**CITY OF TEMPE
DEVELOPMENT REVIEW COMMISSION**

**Meeting Date: 01/08/2013
Agenda Item: 6**

ACTION: Request for a Development Plan Review consisting of replacement of an existing restaurant with a new +/-4,316 sf. restaurant and drive-thru for McDONALDS (PL120398) located at 1525 West Elliot Road. The applicant is Synectic Design, Incorporated.

DEVELOPMENT PROJECT FILE
for
McDONALD'S at ELLIOT & PRIEST

1 SITE PLAN
 AS1.0 1" = 20'-0"
 US BANK NATIONAL ASSOCIATION TR
 TAX PARCEL 301-54-0018H
 DOCUMENT 11-0923978, W.C.R. 11-17-11

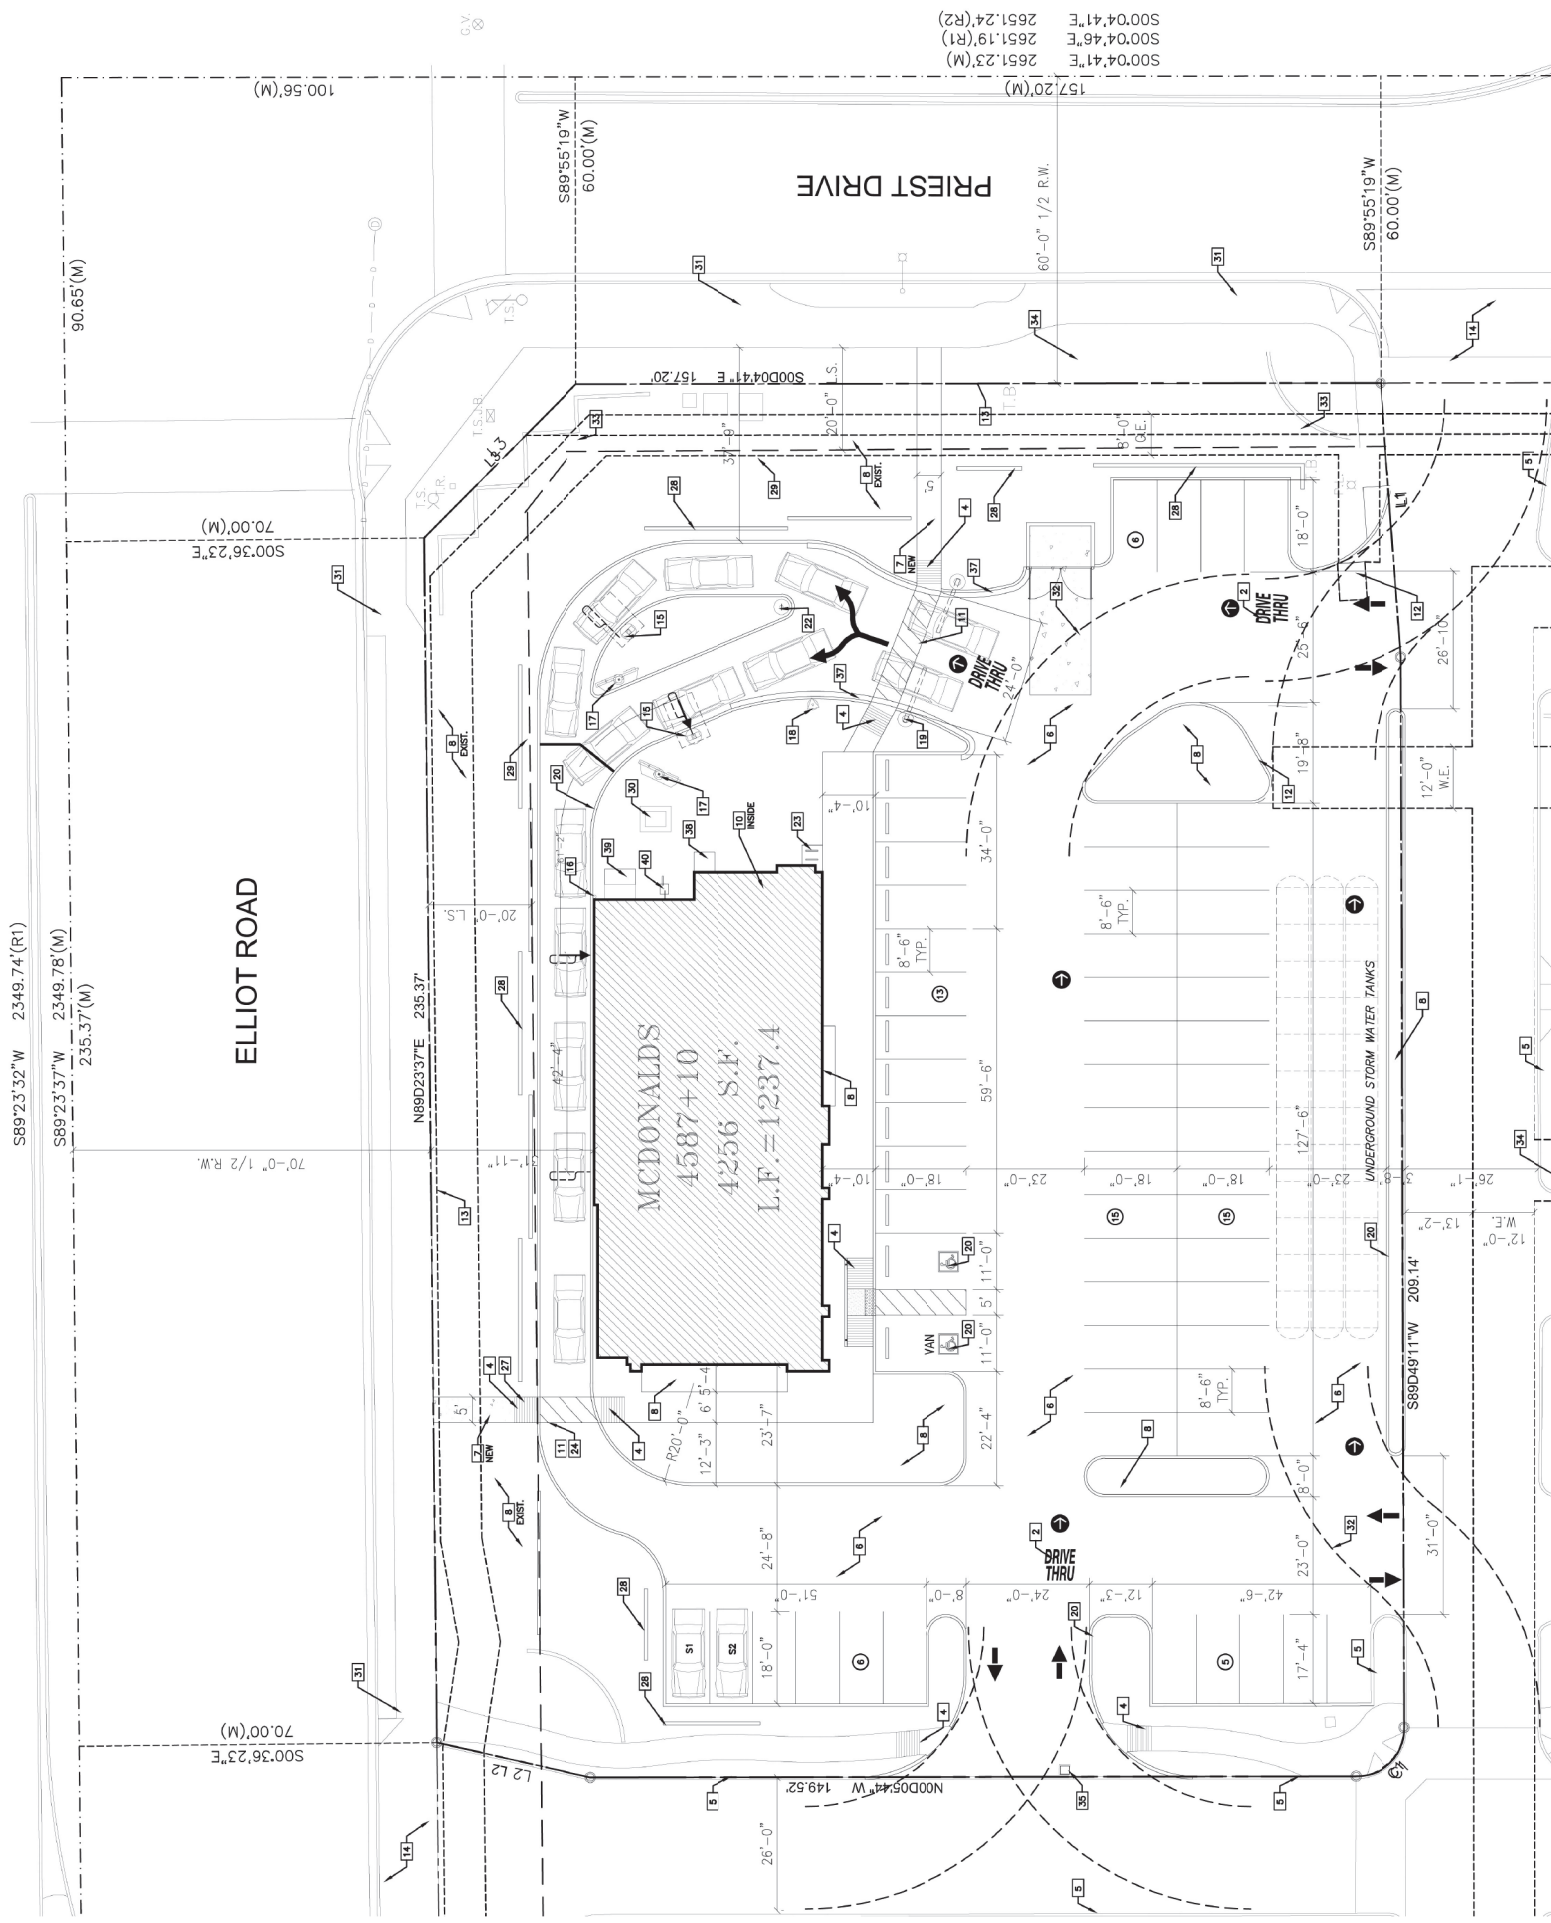
4. Provide a combination of 3'-0" high masonry walls and landscaped earth berms between the drive-through and the street side property lines that work together to form a continuous screen. Finish masonry site walls with exterior plaster all exposed surfaces and paint that compliments building colors. Paint site utility boxes a neutral color that compliments building colors. Do not paint over warning decals or other identifiers.

5. Place disabled accessible parking pair with shared side ramp closest to building entrance on south elevation. Utilize raised curb as tire stop at parking row south of building entrance. Provide 16'-0" long parking spaces on asphaltic concrete parking surface and 2'-0" nose overhang on concrete walkway. Delete pre-cast tire stops in this row. Do not offset curb between disabled accessible and standard parking spaces.

6. Coordinate location of drywell for buried retention structure in a landscape area in compliance with engineering design criteria but do not interfere with required tree or plant ground cover installation.

7. At refuse enclosure, provide gates of steel vertical picket, steel mesh, steel panel or similar construction. Where a gate has a screen function and is completely opaque, provide vision portals for visual surveillance. Provide gates of height that match that of the adjacent enclosure wall.

1
A2.0 FRONT ELEVATION
1/4" = 1'-0"

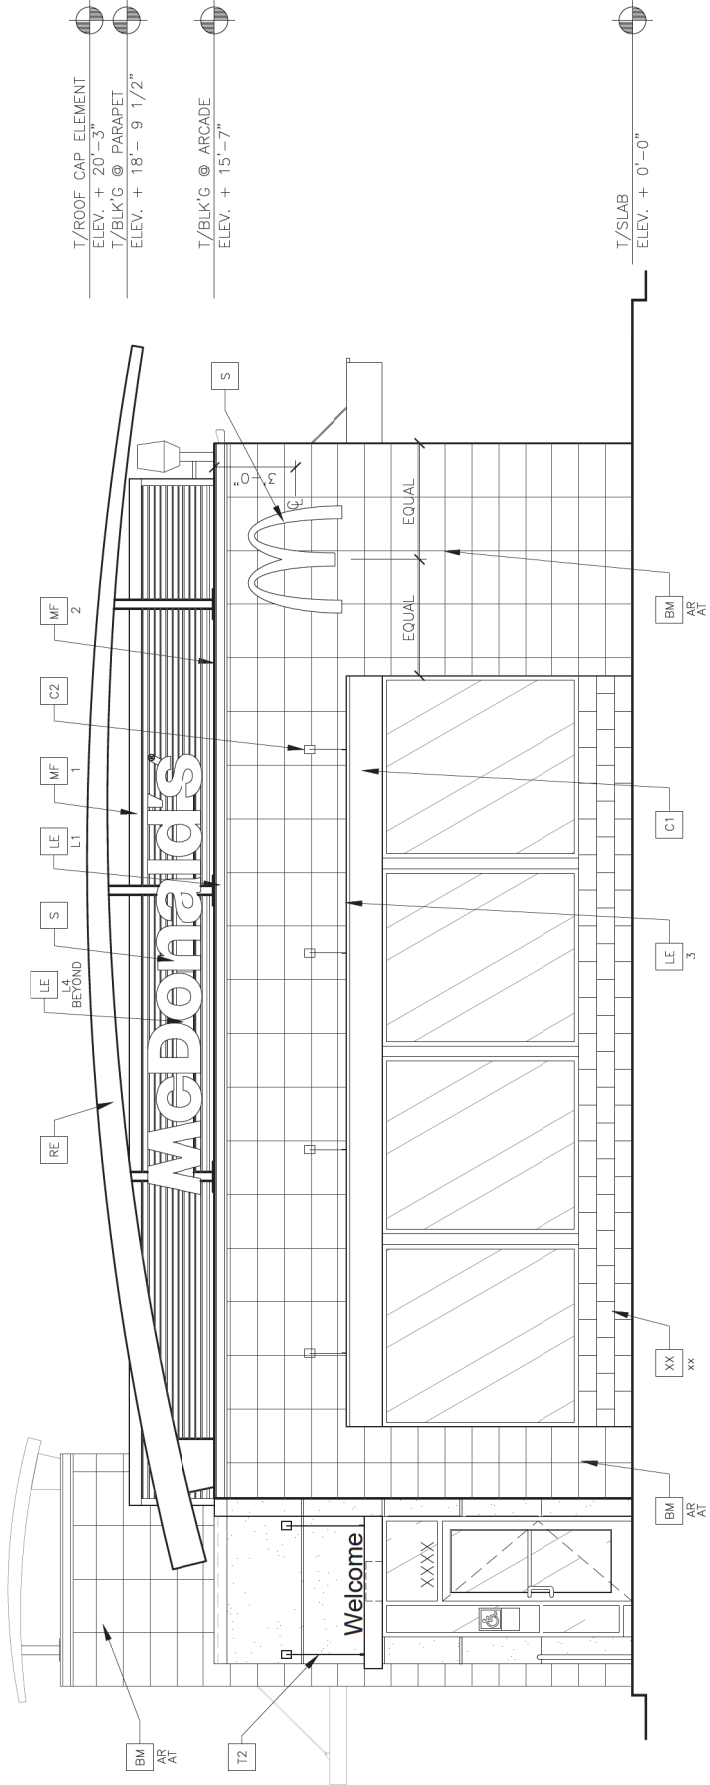
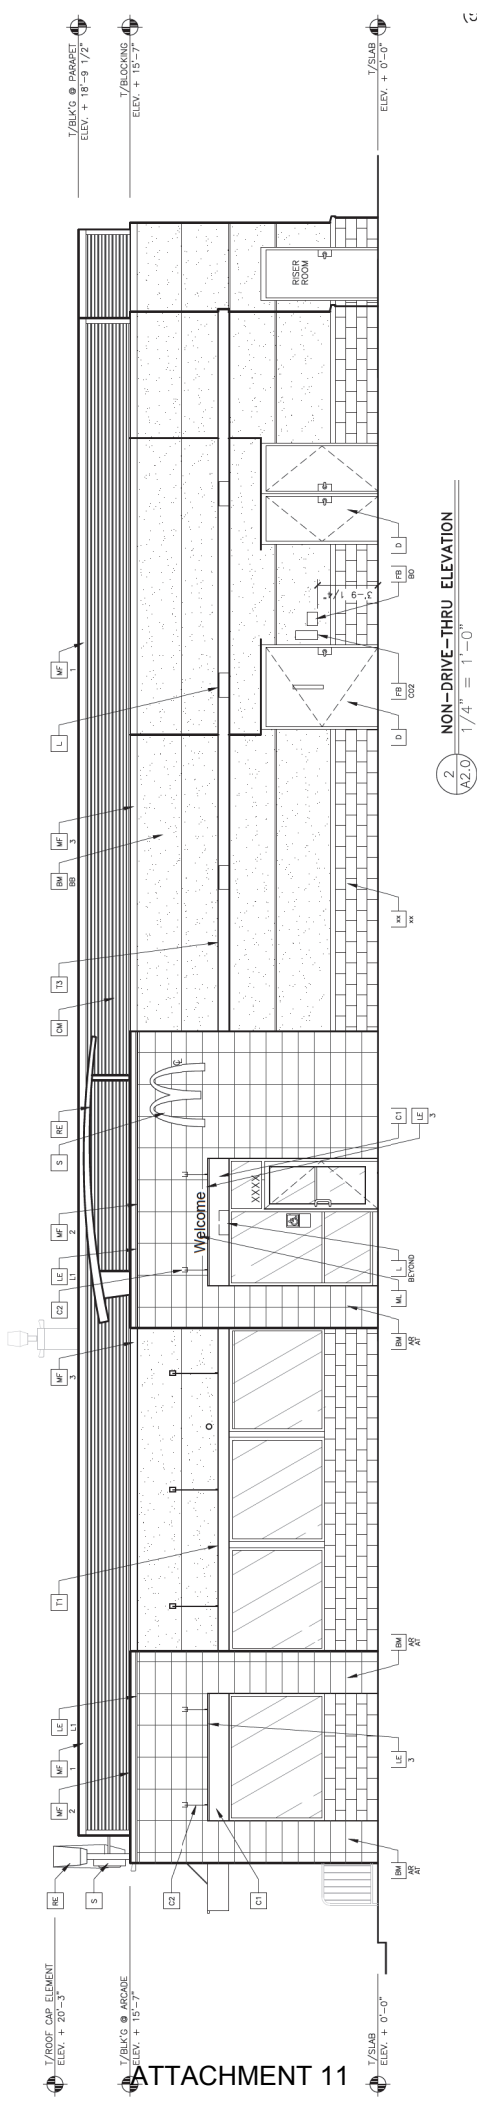
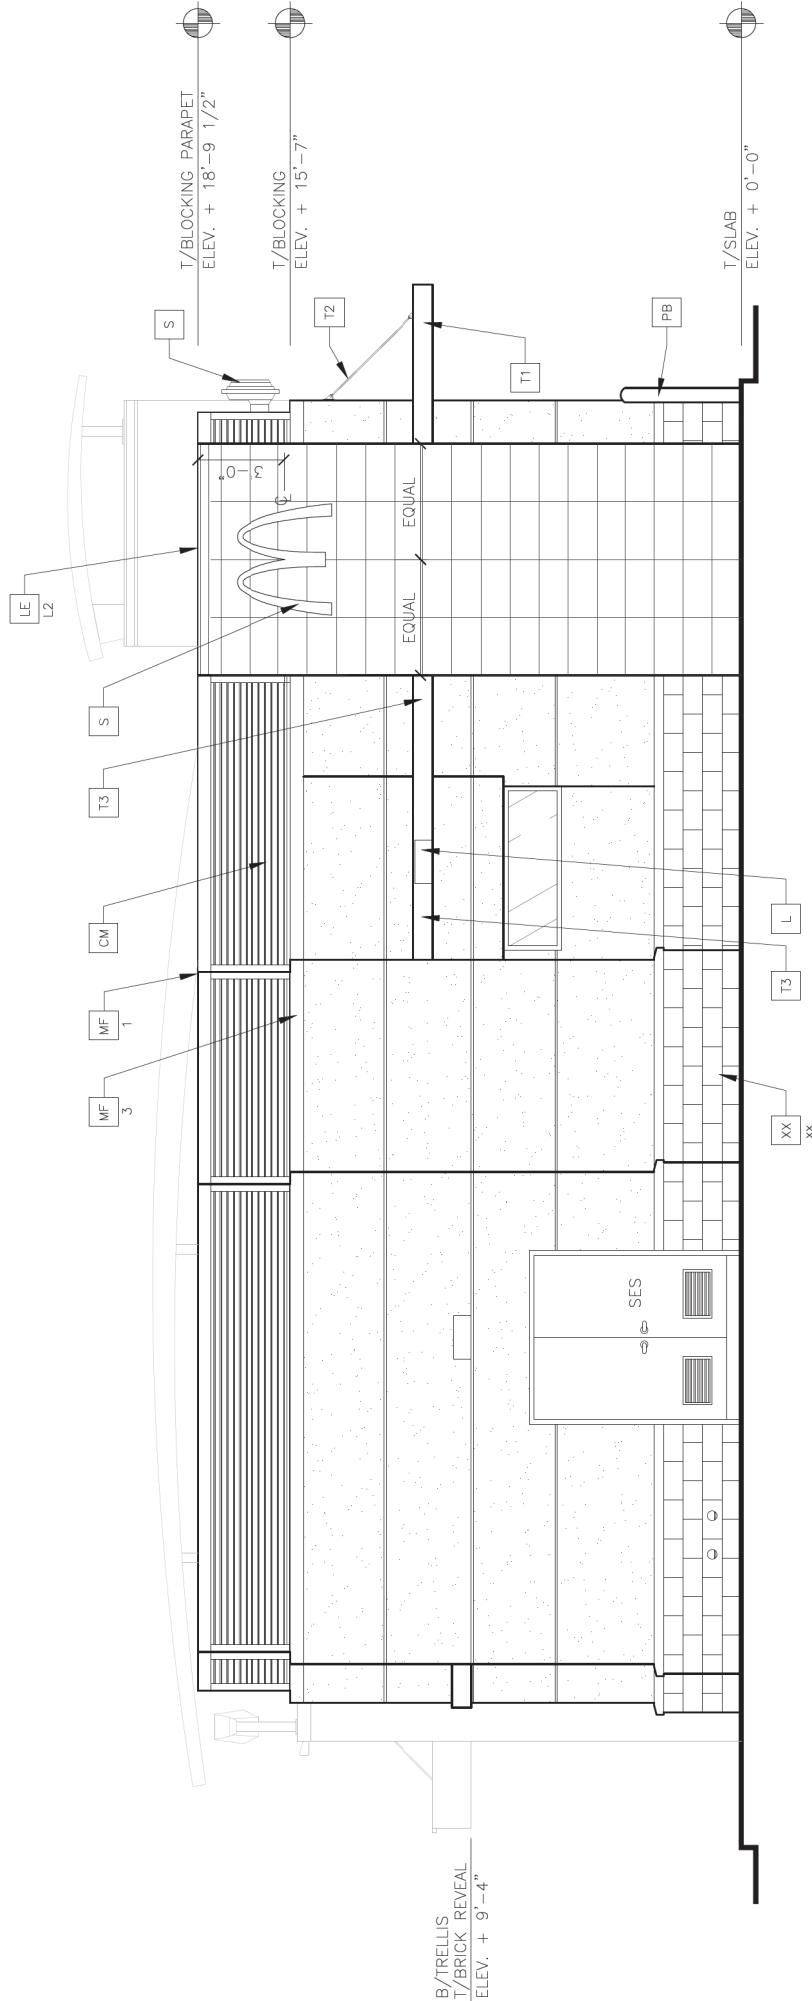
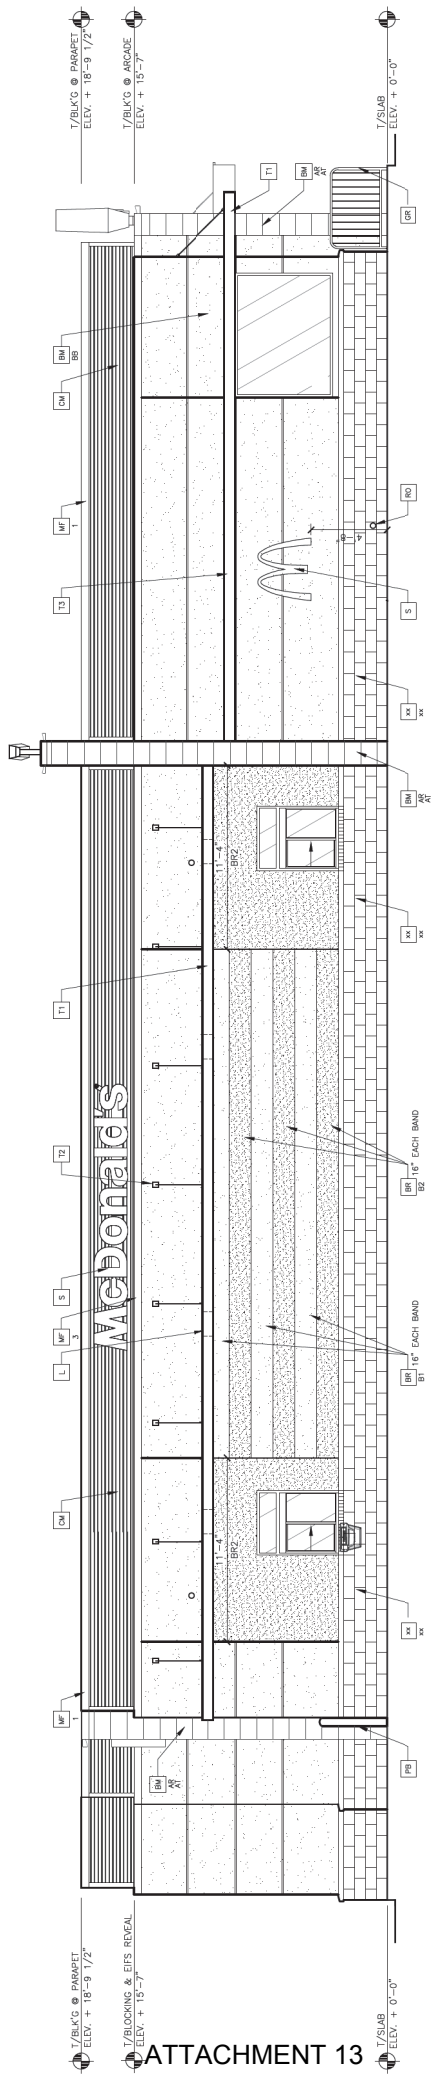
8. The materials and colors are approved as presented on the materials sample board:
 - a. Arcade Tile veneer system at front (west) wall around windows, at southwest corner, at main business (south) entrance and at vertical element on rear (east) wall, manufacturer: Eurowest Tile, Oyster Brushstroke 12"x24"x3/8"

9. Provide secure roof access from the interior of the building. Do not expose roof access to public view. Conceal roof drainage system for portion of roof behind parapet within the interior of the building. Incorporate lighting, address signs, Fire Department Connection and incidental equipment attachments (alarm klaxons, security cameras, etc.) where exposed into the design of the building elevations. Do not locate exposed conduit, piping or similar features on the exposed surfaces of the building.

10. Fully screen ground mount and roof mount mechanical equipment as required by Zoning and Development Code. Raise parapet if necessary to height that matches or exceeds installed roof equipment including top fans, etc. Locate electrical service entrance section and metal panel entirely inside the building or with front panel flush with exterior of building.

11. Exterior door to freezer does not require a vision panel but exterior door to support room does. Provide a vision panel in accordance with the Zoning and Development Code or provide a 360 degree peephole viewer in lieu of the vision panel.

12. Upper/lower divided glazing panels in exterior windows at grade level, such as at south customer entrance and at west entrance near northwest building corner, where lower glass pane is part of a divided pane system, is permitted only if hardened, laminated glazing at the lower pane is provided.
